TOWN OF NEWINGTON  
SYNTHETIC IN-FILLED ATHLETIC TURF  
AT  
CLEM LEMIRE RECREATIONAL COMPLEX

RFP NUMBER 2, 2010-11

ADDENDUM NUMBER ONE

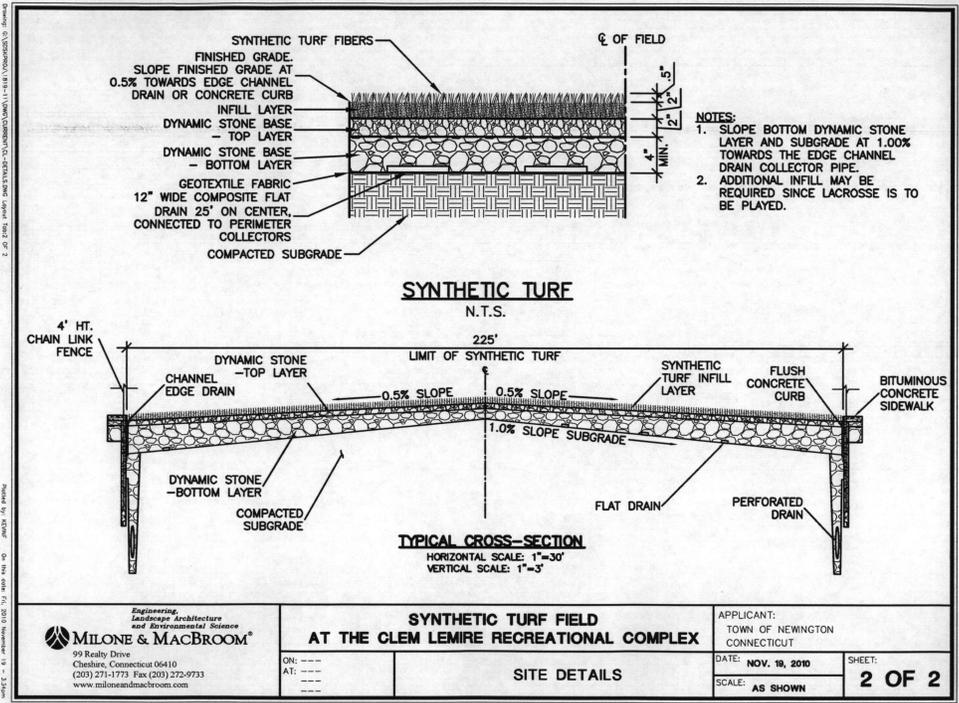
1. In the TECHNICAL SPECIFICATIONS section, ITEM 2-122, PART 2, number 2.1, after letter E. “The fittings used with the collection system shall be of a ‘snap together’ design. In no case shall any product be joined without the use of the manufacturer’s connector designed specifically for the purpose.”, add the letter F. prior to “Dynamic Stone Base-Bottom Layer and Dynamic Stone Base-Top Layer” etc. to differentiate this as a separate specification pertaining to these two layers.
2. The following two drawings, dated November 19, 2010 and labeled “LAYOUT PLAN” and “SITE DETAILS”, respectively, shall be added to the TECHNICAL SPECIFICATIONS section and shall be fully incorporated in the RFP document.

(See drawings below)
